MANUFACTURERS' RECEIVER TROUBLE CURES

VOLUME 2

(Cat. No. 143-2)

Fig. 2 — Emerson

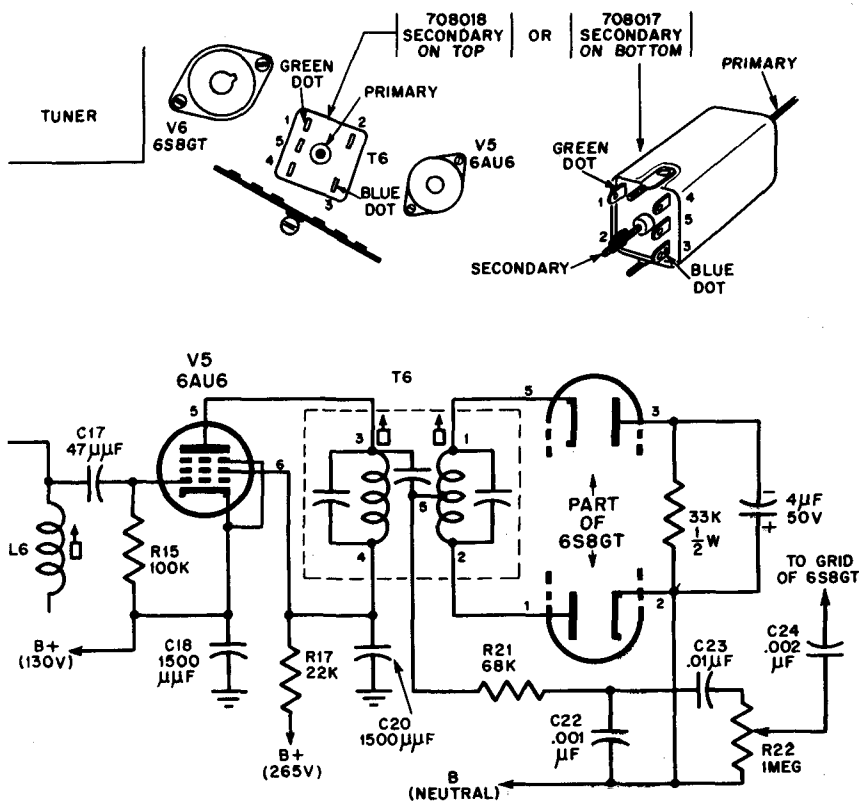
Remove following components from circuit:

2. Two 100-k (*R-19*, *R-20*) resistors from lug 5 of discriminator transformer (*T-6*).

3. *R-16*, *C-19* (8,200 ohms and 1,500 μmf) from pin 6 of *V-5* (6AU6).

5. Remove pigtail of *R-21* (68 k) going to pin 5 of 6S8 and connect to lug 5 of *T-6*.

6. Remove lead from pin 3 of *V-6* (6S8) and connect to pin 5 of *V-6*.

7. Add a jumper wire from lug 4 of *T-6* to pin 6 of *V-5* (6AU6).

Fig. 3 — Emerson

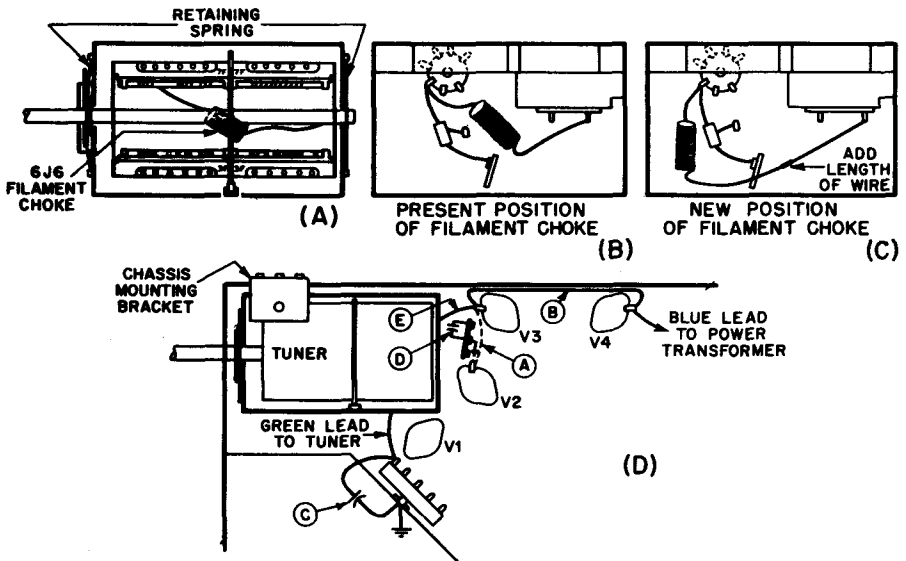
In order to improve the vertical-sync stability, add a 10k-ohm, 1/2-watt resistor (R-93) between C-29 (.047- μ f coupling capacitor between the sync amplifier and the sync separator) and the junction of R-40 (2.2 meg), C-28 (110 μ f), and R-41 (100k ohm). Sets coded Triangle 5 incorporate this change.

Fig. 5 — Emerson

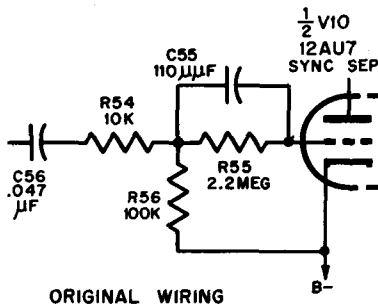
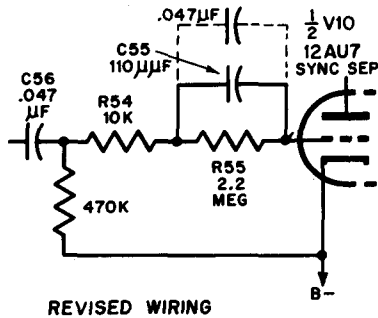
Improving sync stability in fringe areas (see Fig. 5).

The following changes should be made to improve sync stability in fringe areas. Chassis already incorporating this change have the letter *E* stamped inside the code triangle.

Change *R-56* from 100 k to 470 k, ½ watt, repositioning pigtail from junction of *R-54* (10 k), *R-55* (2.2 meg), *C-55* (110 μμf), to junction of *C-56* (.047 μf), *R-54* (10 k) as per figure.

In extreme fringe areas where little external noise is encountered, a .047-μf capacitor may be shunted across *C-55* as shown dashed in the figure.

Fig. 6 — Emerson

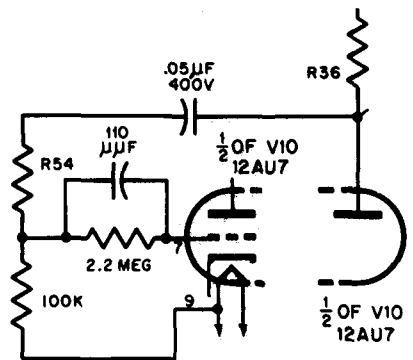
To improve the sync stability in extreme fringe areas, proceed as follows:

1. *R-36* (in plate circuit of sync amplifier) is changed from 10k ohms to 47k ohms.

4. A 2.2-meg resistor in parallel with a 110- $\mu\mu\text{f}$ capacitor is added between pin 7 of *V-10* and *R-54* (old junction of *C-55* and *R-55*).

5. A .05- μf , 400-volt capacitor is added between pin 1 of *V-10* and *R-54* (10k ohms).

6. A 100k-ohm, $\frac{1}{2}$ -watt resistor is added from pin 9 of *V-10* to junction of *R-54*, 2.2-meg resistor, and 110- $\mu\mu\text{f}$ capacitor.

The complete change should alter the schematic as shown in the figure. Some sets in later production runs already contain this circuit modification.

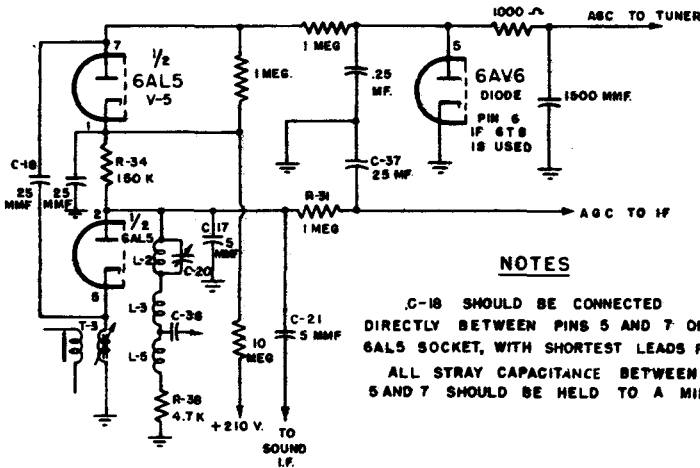
EMERSON Chassis 120129-B, -D
Modification of agc for fringe-area operation (see Fig. 7).

1. Omit R-35 (100 k, $\frac{1}{2}$ watt). This resistor is connected to plate of agc detector.
2. Change R-34 (in plate circuit of video detector) from 22 k to 150 k.
3. Add a 1-meg, $\frac{1}{2}$ -watt resistor from pin 1 to pin 7 of V-5.
4. Remove pigtail of C-18 (25 μ f) from pin 1 of V-5 (6AL5) and connect to pin 7. Note: Wire directly to tube socket keeping stray capacitance and lead lengths to a minimum.
5. Add a 25- μ f ceramic capacitor from pin 1 of V-5 to chassis.
6. Move pigtail of R-31 (1 meg, $\frac{1}{2}$ watt) from pin 7 of V-5 to pin 2 of V-5.
7. Add a 10-meg, $\frac{1}{2}$ -watt resistor from pin 1 of V-5 to B+ 210 volts (C-51 square marking).

Fig. 9 — Emerson

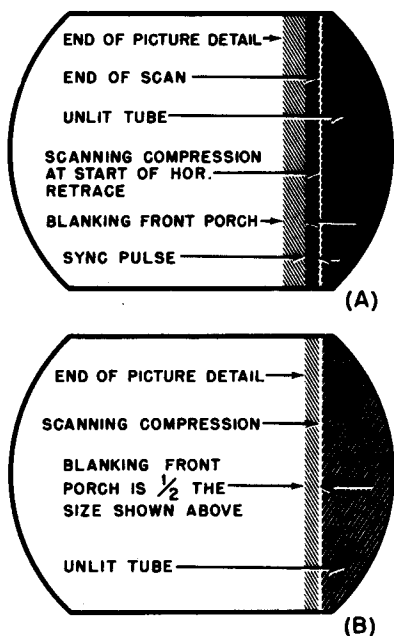
1. Replace *R-75* (220 k in afc feedback circuit) with two 100-k, $\frac{1}{2}$ -watt resistors in series.

2. Connect a 25- $\mu\mu\text{f}$ ceramic capacitor from the junction of the two

100-k resistors to chassis, dressing the components away from the horizontal-phase and frequency coils.

Fig. 10 — Emerson

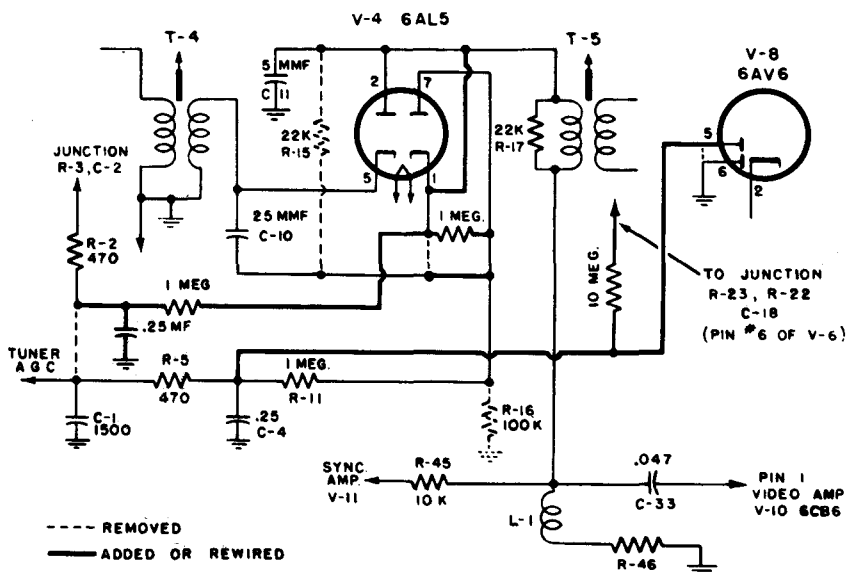
Modified agc for fringe-area operation (see Fig. 10).

The following changes may be made to improve performance, especially in fringe areas, by modifying the agc system to give a tuner delay. This modification will provide an increase in sensitivity.

1. Remove *R-15* (22k, $1/2$ watt) from pins 1 and 2 of *V-4* (6AL5), replacing it with a jumper wire.
2. Remove *R-16*, 100 k, which is connected from pin 7 of *V-4* to chassis.
3. Remove pigtail of *R-2* (470 ohms) resistor from lug on terminal board and reconnect to empty lug on same terminal strip. This resistor is in the grid circuit of *V-1*.
4. Add a white jumper wire from new position of *R-2* to the empty lug

5. Add a 1-meg, $\frac{1}{2}$ -watt resistor from this empty lug near audio-output transformer to pin 7 of V-4.

6. Add a .25- μ f, 400-volt capacitor from above point on terminal strip to chassis.

7. Remove pigtail of C-10 (25 μ f) from pin 1 of V-4 and connect to pin 7 of V-4.

8. Add a 1-meg, $\frac{1}{2}$ -watt resistor from pin 1 to pin 7 of V-4 (6AL5).

9. Remove all ground connections from pin 5 of V-8 connecting center shield pin to pin 6, if not already there.

Fig. 15 — Fada

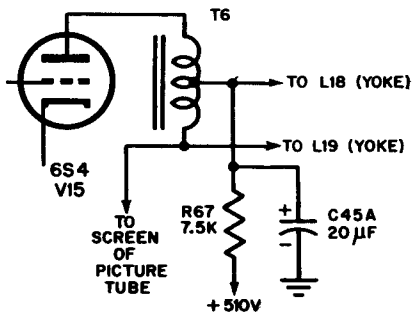
1. Disconnect screen (pin 10) of picture tube from junction of C-57 and C-58, and reconnect to junction of

L-19 of the yoke and the B+ terminal of *T-6*.

2. Reconnect the B+ input to the vertical-output stage, to the tap on *T-6* as shown in the figure.

Fig. 16 - Fada

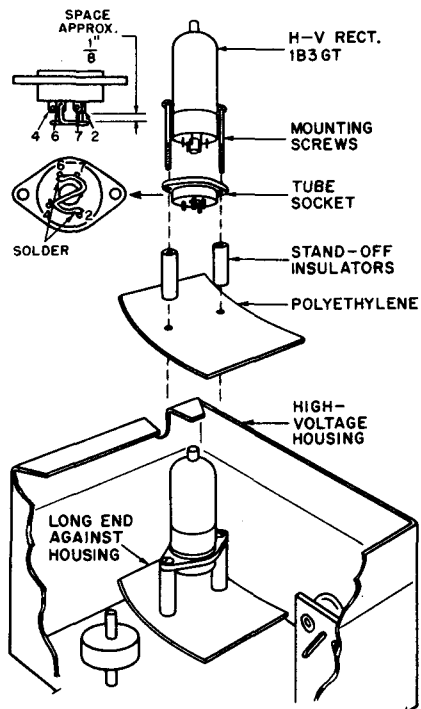
Remove the 1B3 socket assembly from the chassis by removing the two screws that mount the socket assembly on the chassis. Remove the 1B3 tube from its socket and turn the socket over. The socket should be checked for lint, spider webs, and sharp wire or solder points.

Place the plastic insulator strip on the chassis with the long end toward the h-v cage as shown on the sketch. When the socket assembly is remounted, care should be taken that the filament link and leads are kept as far away as possible from the main coil of the horizontal-output transformer, since otherwise corona may result between these two points.

In areas of high humidity an additional change may be necessary if corona still exists under the 1B3 socket. The one megohm resistor mounted on the socket should be replaced with an S-shaped corona ring, constructed of heavy solid wire. The corona ring should be mounted so that all the lugs of the socket are in line with the corona ring, as shown on the attached sketch. In most cases the corona ring will not be necessary; it should be used only when required.

Fig. 18 - Gamble-Skogmo (Coronado)

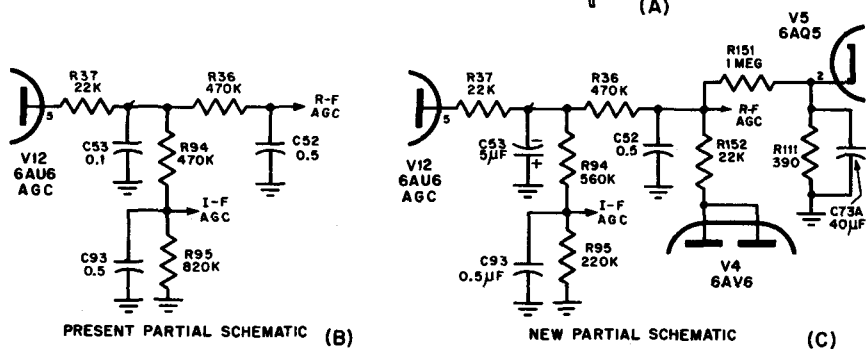
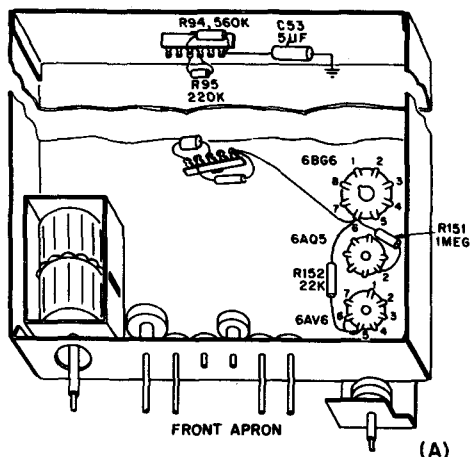
To improve the signal-to-noise ratio in fringe areas on the models listed above, the changes in the agc circuit shown in the partial schematics are suggested. Part numbers and descriptions of the parts to be removed and added are listed.

Fig. 20 — General Electric

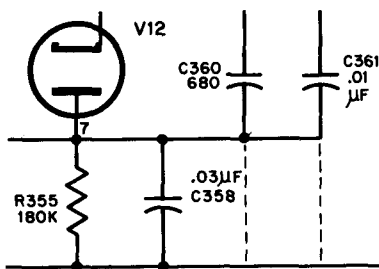
Curl at top of picture (see Fig. 20).

A few receivers have shown a slight displacement (to the right) of the first few horizontal scan lines which shows up as a slight curl at the top of the picture. This trouble is caused by a delay in recovery of the horizontal afc circuit after the occurrence of each vertical sync pulse, and is compensated for by feeding a correction voltage of proper magnitude and phase into the afc circuit. The circuit revision is shown in the sketch; the procedure follows:

Fig. 22 — General Electric

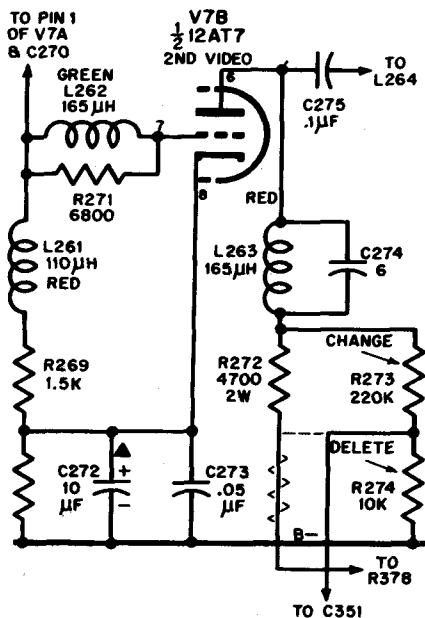
Correcting bending at top of picture (see Fig. 22).

In early production receivers R-273, R-274 and the sync voltage take-off capacitor C-351 were connected as shown in the figure. To correct bending at the top of the picture R-274 is deleted. R-273 is changed to 220 ohms and is reconnected in series with R-272. C-351, the sync-coupling capacitor, is now connected at the junction of R-272 and R-273 as shown in the dashed lines.

Fig. 25 — General Electric

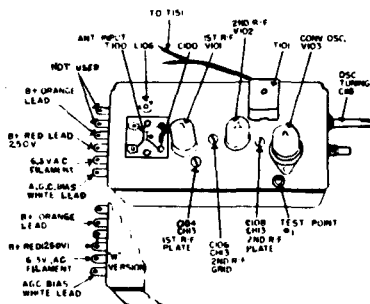
F-M interference reduction in tuner (see Fig. 25).

In order to reduce f-m interference the resistance *R-103*, (3,300 ohms, 1/2 watt) in the tuner is increased to a value of 5,600 ohms, 1 watt, part No. URE-067. The r-f tuner with this new resistor is stamped "W" for easy identification. To compensate for the higher voltage drop the B+ to the tube *V-101* is increased from 160 to 250 volts. This is accomplished by moving the orange wire (B+ 160 volt) to the second lug from the top (see figure) and connecting the third lug with the fourth lug which connects the B+ for *V-102* to the B+ 250-volt red lead.

Fig. 26 — General Electric

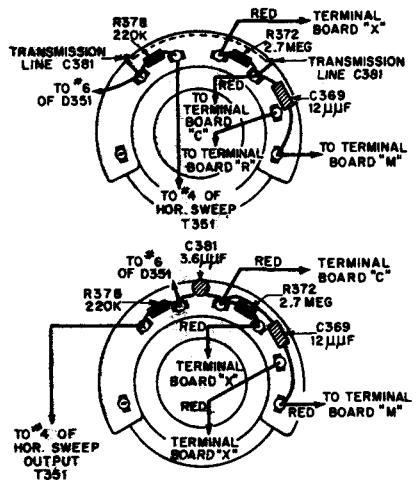
Improved deflection-yoke installation (see Fig. 26).

The early production yoke RLD-030 which is identified by the markings on the yoke as follows "M77J11-10- #33, blue code dot on the winding tape" is replaced by the yoke RLD-037. The use of this improved yoke necessitates the installation of a variable trimmer, *C-302*, RCY-069 (1 to 12 mmf). The trimmer is connected to the yoke terminal 8 and chassis ground. A lead is already provided on the yoke for this purpose.

Fig. 29 — General Electric

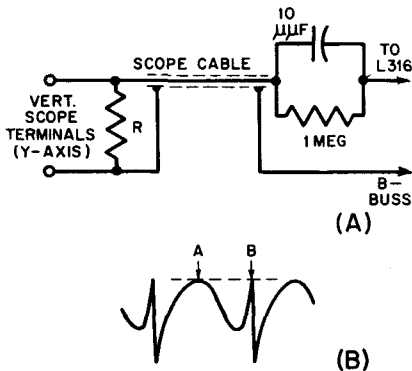
(see Fig. 29).

On the above production receivers, a tuned circuit is added to the horizontal blocking oscillator circuit to stabilize the sync. The method des-

Fig. 37 — Hoffman

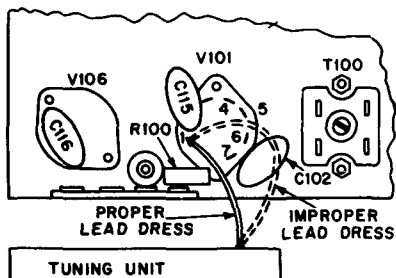
Channel-11 picture interference
(see Fig. 37).

Receivers with the above listed chassis produced prior to serial No. E906732, used the conventional sound i-f take-off from the tuning unit. In these chassis, a number of cases of interference in the form of a fine herringbone pattern on channel 11 only have been observed.

Fig. 43 — Hoffman

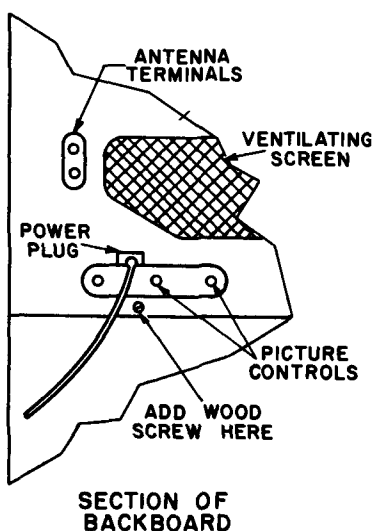
HOFFMAN Chassis 146
Power-cord interlock looseness (see Fig. 43).

Fig. 45 — Hoffman

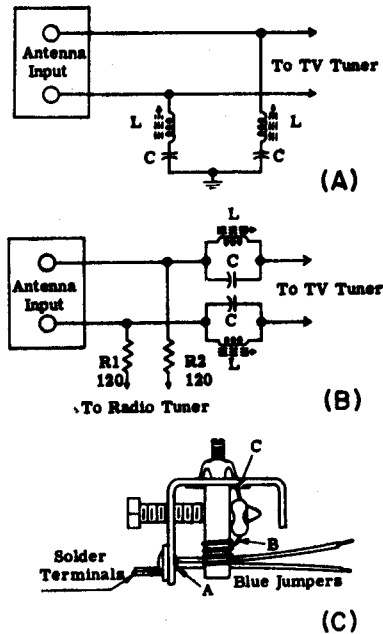
Interference trap for channel 2 (see
Fig. 45).

Fig. 50 — Hoffman

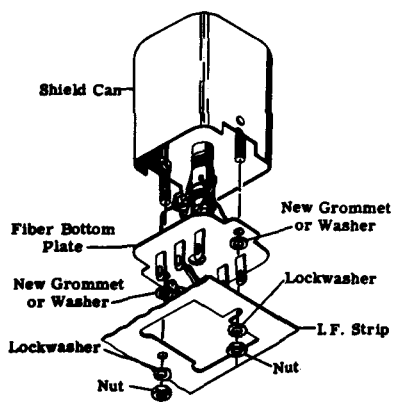
**Mounting modification of 3rd i-f
transformer shield (see Fig. 50).**

Fig. 51 — Hoffman

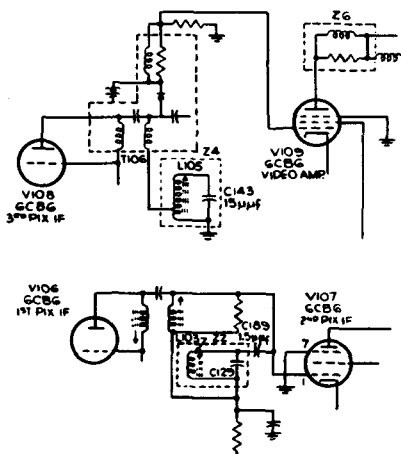
Removing 4.5-mc beat interference (see Fig. 51).

Fig. 58 — Hoffman

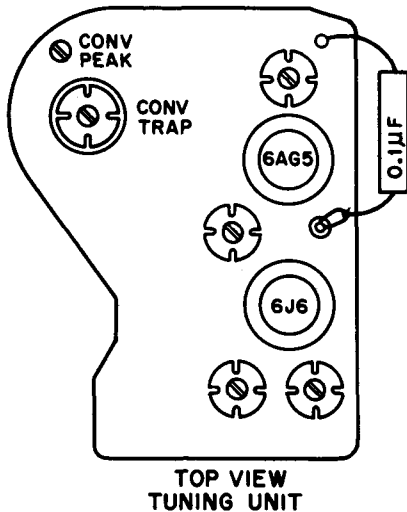
HOFFMAN Chassis with turret tuners RF-3 through RF-6
Tunable modulation hum (see Fig. 58).

Fig. 59 — Hoffman

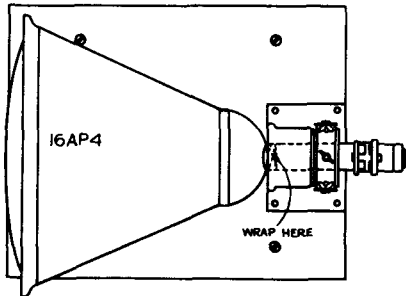
HOFFMAN Chassis with
16-inch metal picture tubes
**High-voltage arcing around
picture-tube neck (see Fig. 59).**

Fig. 63 — Industrial

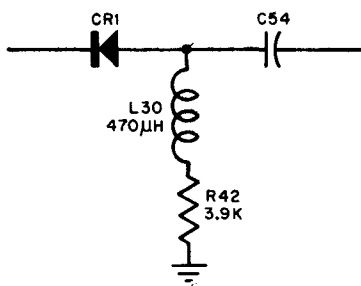
INDUSTRIAL Chassis IT-35R
Improvement in video response
 (see Fig. 63).

Fig. 65 — Jackson

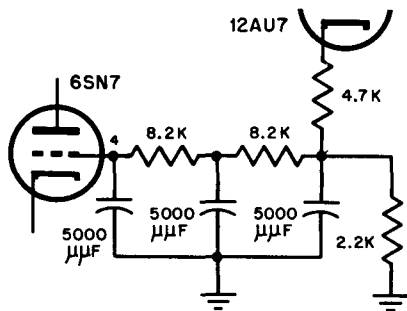
1. Remove vertical-integrator plate.
2. Make up vertical integrating circuit as shown in the the figure.
